**Further Assessment of Transmission
Investment Proposed by the Three GB
Electricity Transmission Owners: Review
of Requests for Funding for 2011/12 –
Final Report**

London, 20 January 2011

Client: Ofgem

Figure 8 – The effect of the Western HVDC Link on system losses

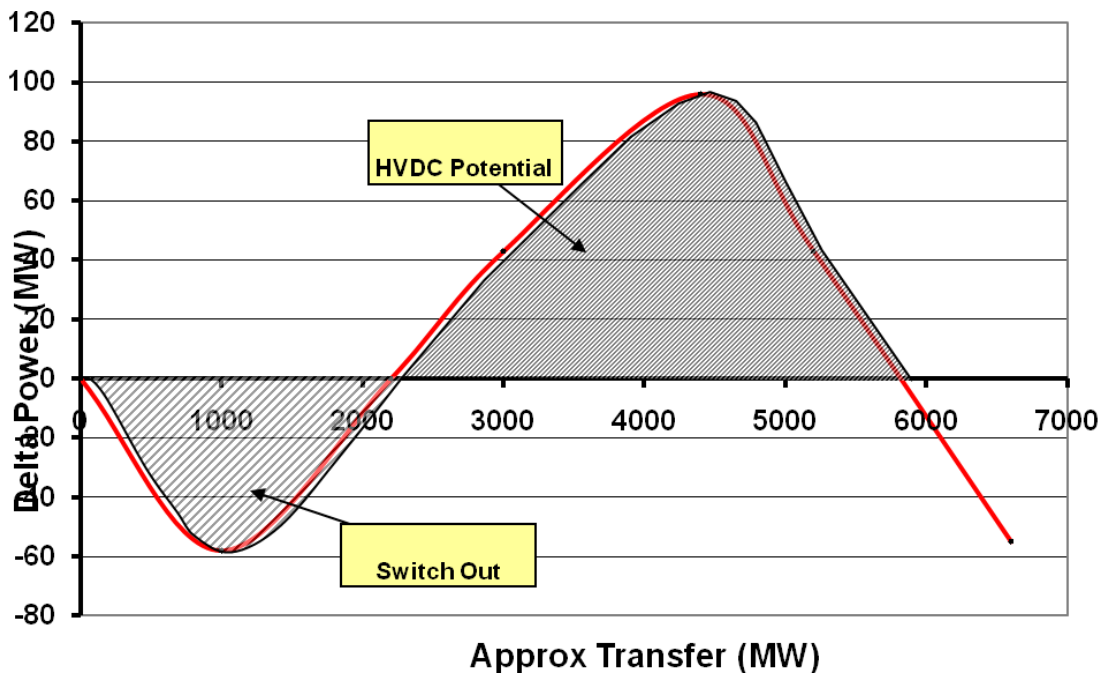
The original CBA report suggested that the Western HVDC Link reduces losses from 1668 MW/10.6 TWhr to 1518 MW/9.9 TWhr. This appeared a high reduction in losses, equating to a reduction of 150 MW/0.7 TWhr. Consequently KEMA requested further explanation from NGET.

NGET's graph below shows how the savings in losses from installation of the Western HVDC link vary according to power flow across boundary B6. At low transfer levels (less than ██████████) the fixed losses in the link dominate, and the presence of the link actually results in increased losses (the operational solution would therefore be to switch it out of service).

As the transfer increases to 4.4 GW the saving in losses increases, until at 4.4 GW it is a saving of about 100 MW.

Figure 11: TEC associated with each site in East Coast

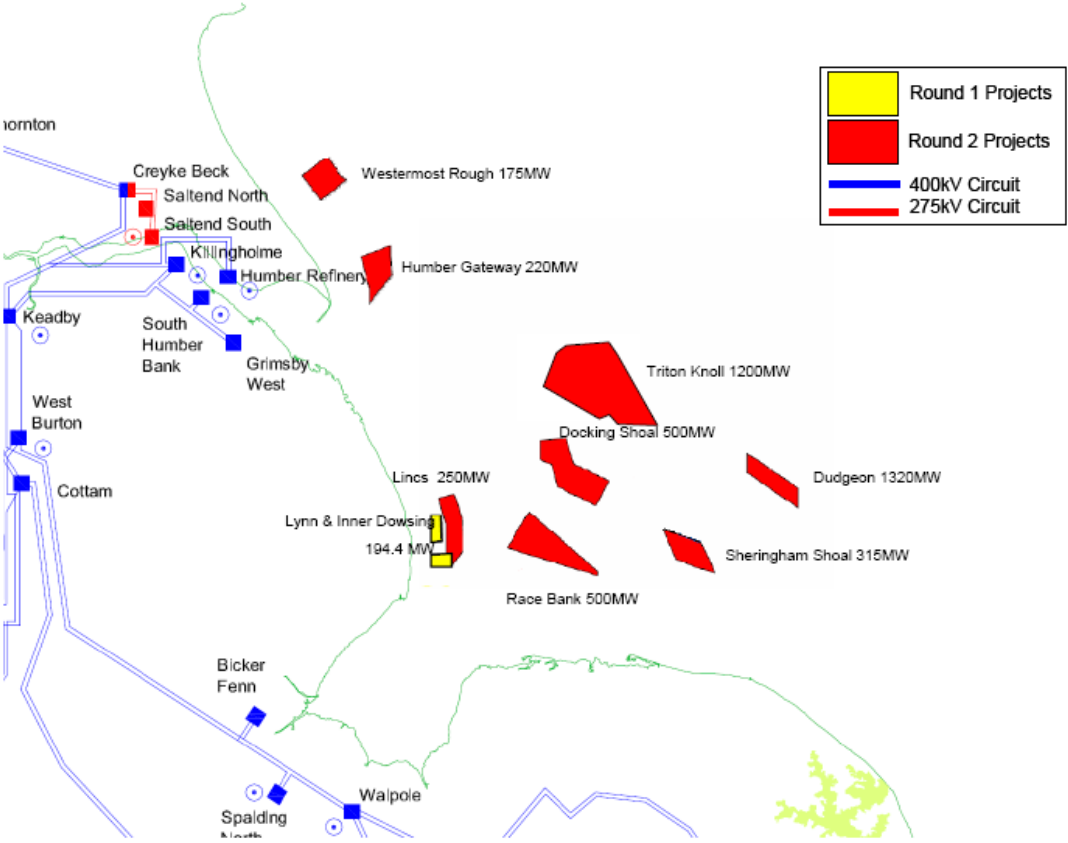
There is clearly a requirement for some transmission out of Mumby, to connect it to the system. In the Seven Year Statement this is stated to be a new line from Mumby via Bicker Fen to connect into the Cottam - Eaton Socon line in 2018. The location of the connection point on the Cottam – Eaton Socon circuits was not specified, although NGET’s submission suggests Bainton, near Peterborough.

At first sight, terminating this new line on the Eaton Socon line at Bainton would seem to be preferable to termination at Walpole: there is already a large amount of generation connected at Walpole and injecting additional power from the north at this site runs the risk of overloading the system to the south of Walpole.
